D/DRC Case

500 Huger St. & S/S Blossom St.

DESIGN/DEVELOPMENT REVIEW COMMISSION
DESIGN REVIEW DISTRICT
EVALUATION SHEET
Urban Regular Agenda – Case 2

NATURE OF REQUEST: Request for a Certificate of Design Approval for new construction of a private student dormitory.

SITE PLAN

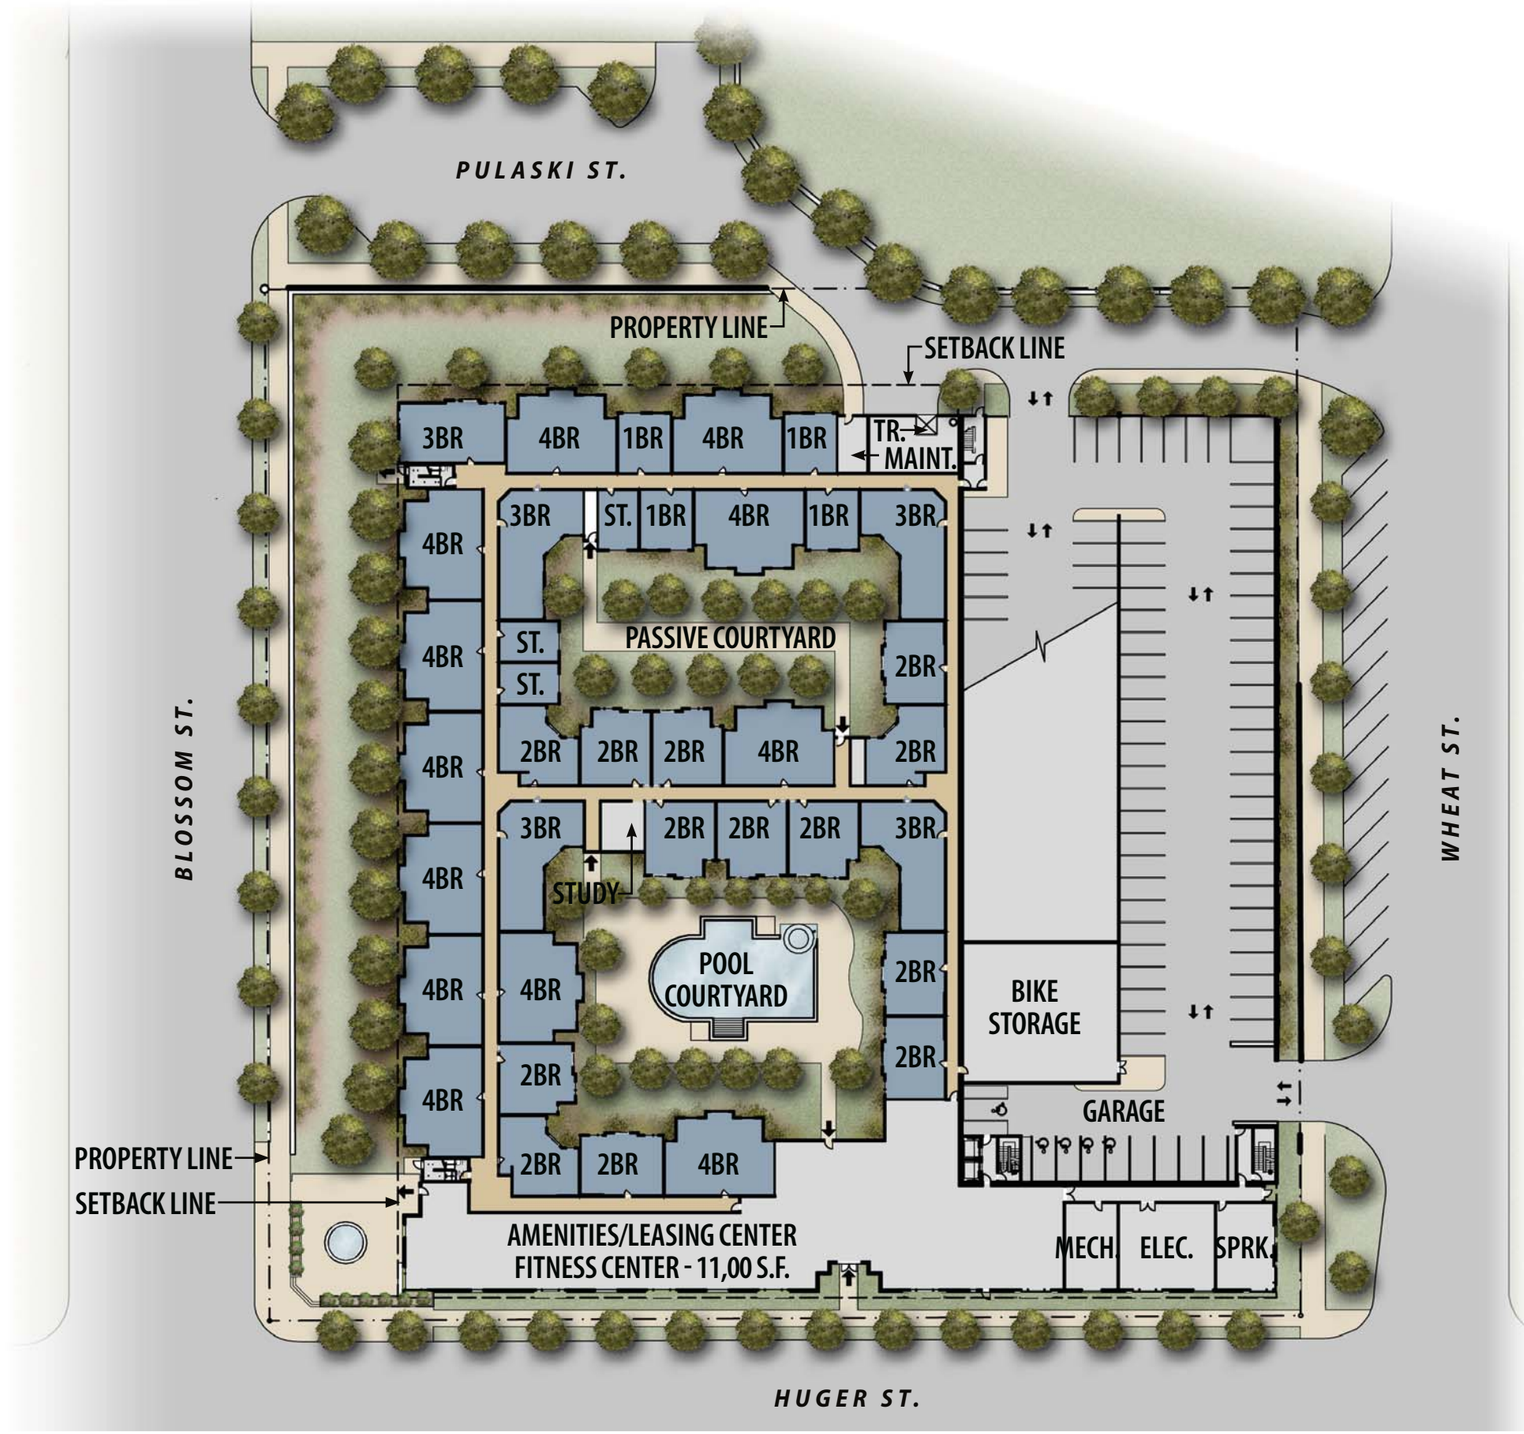
The applicant also is proposing construction of parking spaces in the Wheat Street right-of-way. The site plan shows a 10-foot sidewalk, an 8-foot planting area, and angled parking on the north side of the street. Curb extensions occur at driveways and intersections. Driving lanes have not been indicated.

Staff recommends that the parking and pedestrian amenities within the Wheat Street right-of-way be planned and constructed substantially similar to the Innovista Master Plan. (Note: perpendicular parking is not recommended, and is not supported by Streets, Engineering, or Public Works.) The cross section of improvements for the northern portion of Wheat Street should include the following:

- Property line/ Min. 10 foot sidewalk/ Min 8 foot planting Strip/ parallel parking / driving lane/ turn lane/ and driving lane.

The applicant is proposing constructing sidewalks, parking, and driving lanes within the Pulaski Street right-of-way south of the Blossom Street access road. The site plan shows a 10-foot sidewalk, an 8-foot planting area, and angled parking on the east and west sides of the street. Curb extensions occur at driveways and intersections. A turn around area has not been provided.

Staff recommends that the parking and pedestrian amenities within the Pulaski Street right-of-way be planned and constructed substantially similar to the Innovista Master Plan, with one major deviation of providing angled parking rather than parallel parking. (Note perpendicular parking is not recommended, and is not supported by Streets, Engineering, or Public Works.) The cross section of improvements for the northern portion of Wheat Street should include the following:

The current design anticipates two driveways and allowing vehicles to turn around. It is recommended that driveways be designed with curb cuts, the side walk be continuous and loop, and that a turning radius area be provided to allow for vehicles to turn without accessing the driveways.

As located, the parking structure is located 10 feet from the Wheat Street and significantly more than 10 feet from Pulaski Street property line, due to the private drive to access parking, refuse areas, and Pulaski Street right of way.

Comments and Recommendations
The location of the parking structure is consistent with this guideline with the exception of the setback from the Pulaski Street right of way. The DDRC should consider a deviation to the guidelines due to the wetlands located in the Pulaski Street Right of Way.

1. Right-of-way improvements shall be completed and approved through a permanent encroachment process to the satisfaction of the city's reviewing departments, and done so to comply with the Innovista Master Plan;

1 PARTIAL ELEVATION @ PARKING GARAGE
SCALE: 1/2" = 1'-0"

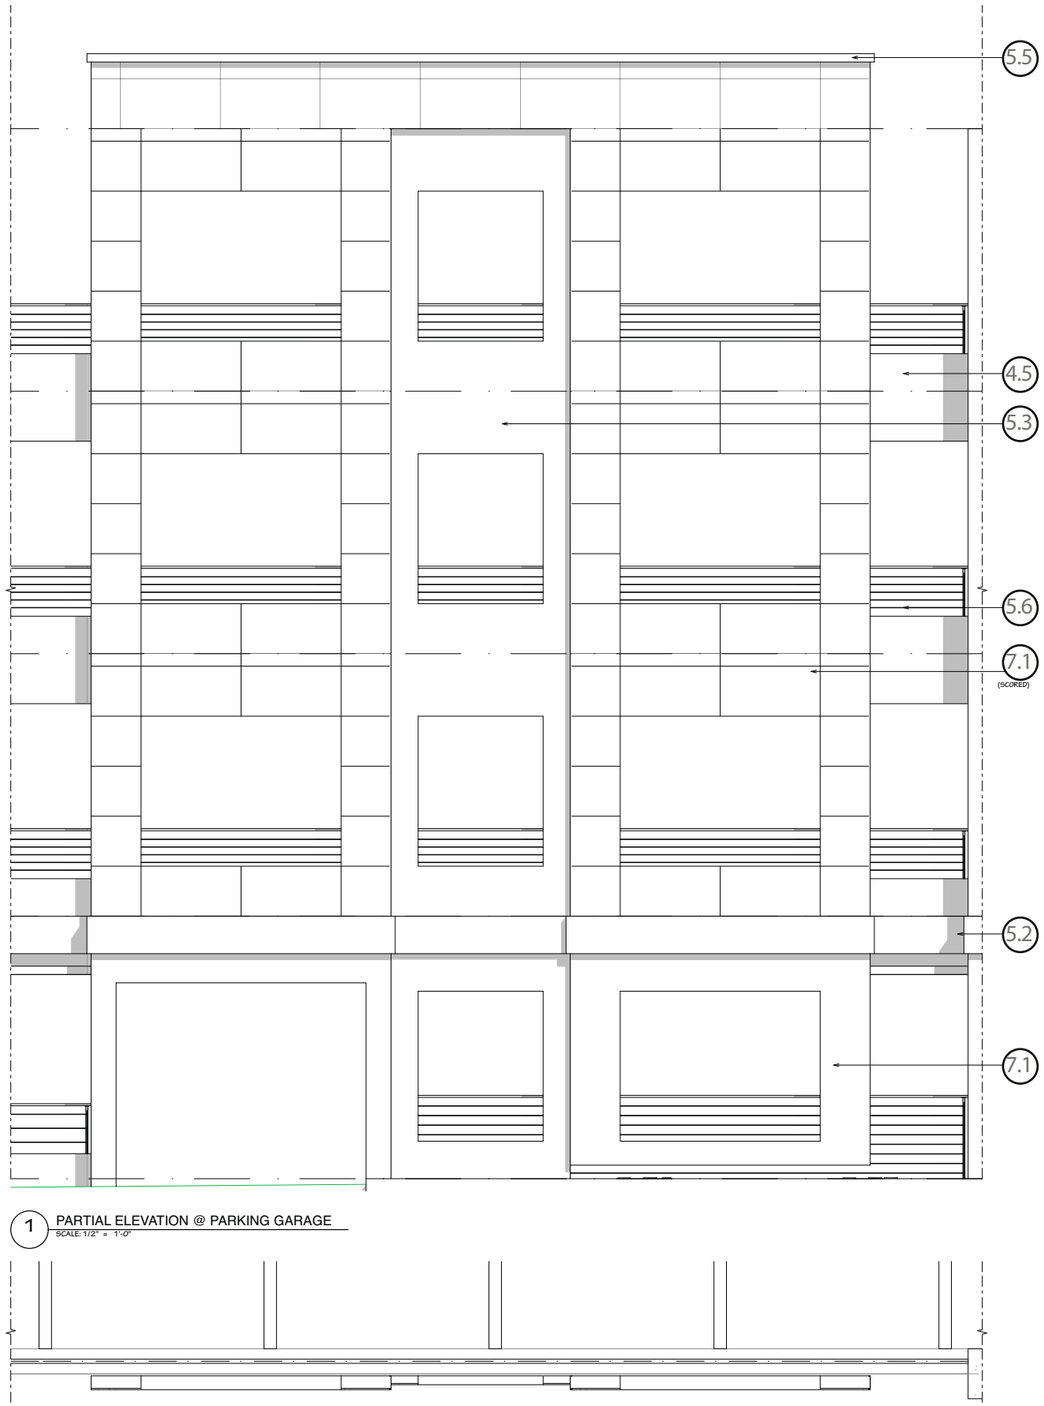
Comments and Recommendations
Neither steel mesh panels nor precast concrete are materials used in the façades of the principal private dormitory structure. Compatibility of the two structures is an important aspect in design continuity for the site, but also for the creation of the streetscape/ pedestrian-realm adjacent to the site.

The parking deck does not have any broken sections constructed into the façade of the structure. A similar treatment could be created through the use of material changes and/or landscaping elements. Neither of these items is proposed at this time.

The Wheat Street façade of the parking deck does not appear to have any fenestration or alterations in the façade to provide a sense of scale and place for the pedestrian. The comments under 1.2 "Structured Parking" also address many similar design items.

The parking deck along Wheat Street does not have an analogous material or articulation pattern as the rest of the residential structure.

3. Detailed vehicular and bicycle parking plans shall be provided to staff to ensure compliance with all parking requirements;
4. Final detailed design and material specifications for the parking deck façades shall be provided;
